SERVICE BULLETIN

ENGINE – HP TURBINE ROTOR AND STATOR ASSEMBLY – PROVIDE NEW STAGE 2 TURBINE ROTOR HUB
WITH INCREASED FRONT SNAP DIAMETER – CATEGORY CODE 7 – MOD.ENG-72-0145

V2500-ENG-72-0145

Location of the Stage 2 Turbine Hub
Fig.1

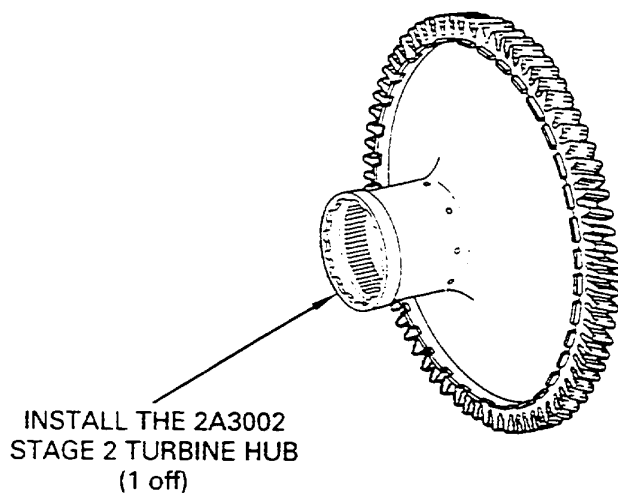
The front snap diameter of the stage 2 Turbine Hub must be increased to make sure that the cyclic life of the part is kept.

- (1) Do a modification of the Stage 2 Turbine Hub to increase the front snap diameter.
- (2) For the effect on declared life see Reference (3), 5-10-01, Group A Parts Lives.

- (1) Install the 2A3002 Stage 2 Turbine Hub by the procedure given in Reference (3), Chapter/Section 72-45-00, Assembly-01. Refer to Figure 2.
- (2) Identify the new Stage 2 Turbine Rotor Assembly as 2A2822. Use the procedure given in Reference (2), Control No./TASK No. 70-09-00-400-501.
